**Assabet River, Massachusetts
Sediment and Dam Removal Feasibility Study**

**ASSABET RIVER
SEDIMENT AND DAM REMOVAL FEASIBILITY STUDY**

Department of the Army
New England District
U.S. Army Corps of Engineers
Concord, MA
September 2010

Figure 3. Assabet River Dams and Impoundments

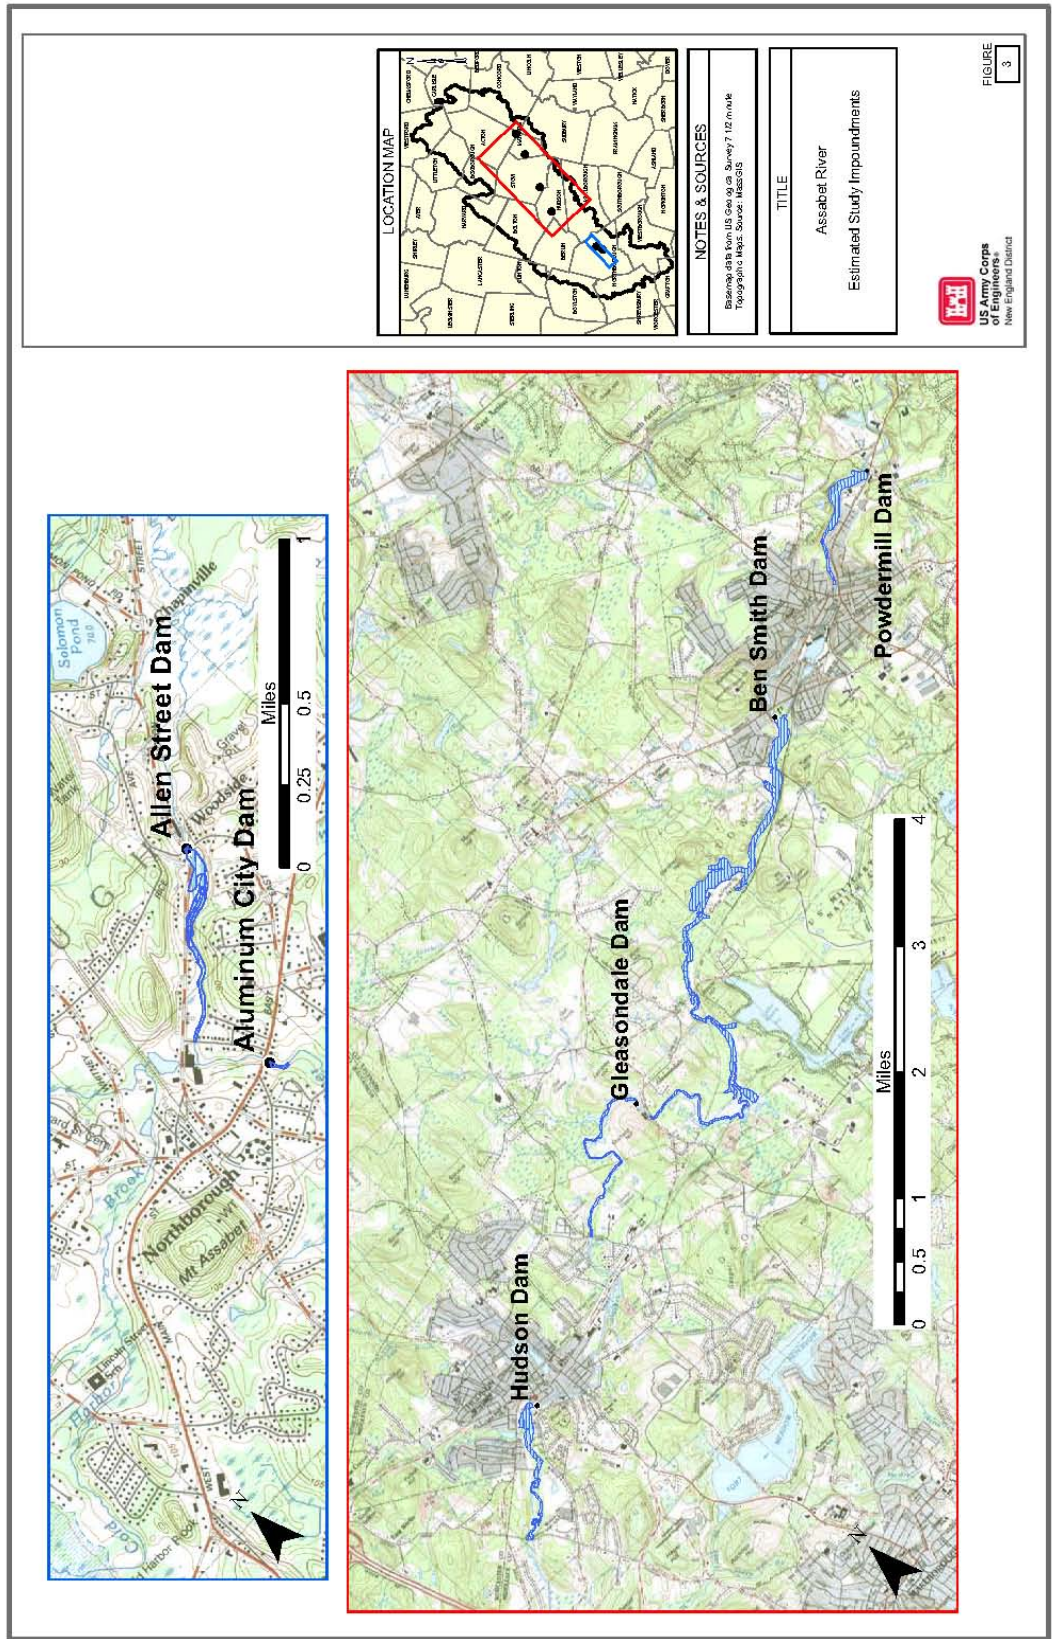
- Page 5, bottom paragraph: Please define how the Study defines the term “impoundment” behind the dams, or the “visual impoundment”, which in some cases (e.g. Ben Smith Dam) is smaller than the length of the river that is affected by the dam. See for example Figure 2 which shows a much larger length of river affected by the dam than the estimated impoundment length and area shown on Table 4, General Dam and Impoundment Characteristics.

Corps Response: The extent of influence of the Ben Smith Dam based on CDM modeling is approximately 5 miles. The new Figure 3 was added to report illustrates the extent of influence of the dam. The USGS report Page 40 list the length of the Ben Smith impoundment as 11,000 meters which converts to 6.8 miles. The Corps has no information to indicate that the 5 miles should be changed to 6.8 miles at this time in Table 4.

Corps Response: This has been rewritten in report to clarify numbers presented. A new Figure 3 has been added showing the extent of dam influence.
